Newmar Corporation

RSB 613
November 1, 2024

NHTSA #24V 787
TC #2024-629

RECALL SERVICE BULLETIN

Instructions for Valve Stem Extension Recall 24V 787

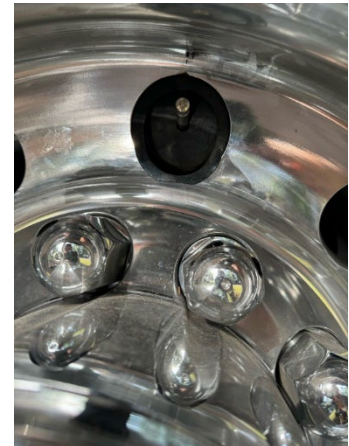
Inspect the rear wheels to see if valve stem extensions are installed on your coach.

If valve stem extensions are installed, take pictures of each wheel. Then submit your information and the photos via Newmar's recall form. If valve stem extensions are installed, proceed with the following recall instructions to remove the valve stem extension(s). There is no need to take the coach to a dealership to have the recall completed.

1. Remove the valve stem cap.
2. Remove the rubber grommet from the outer rim.
3. Remove the valve stem extension from the rear inner dual tire by rotating the extension counterclockwise.
4. Test and adjust the rear inner tire pressure to ensure correct air pressure and that air loss did not occur while removing the extension. This can be checked using a long, truck-style tire pressure gauge and a long, truck-style air chuck.
5. Install the valve stem cap you previously removed using long nose pliers or a valve capper tool.
6. Take a photo of the rear tire and rim showing the extension and grommet have been removed.
7. Scan the QR code or use web link below to fill out the recall form. Remember to attach the pictures you took to verify the recall has been completed.
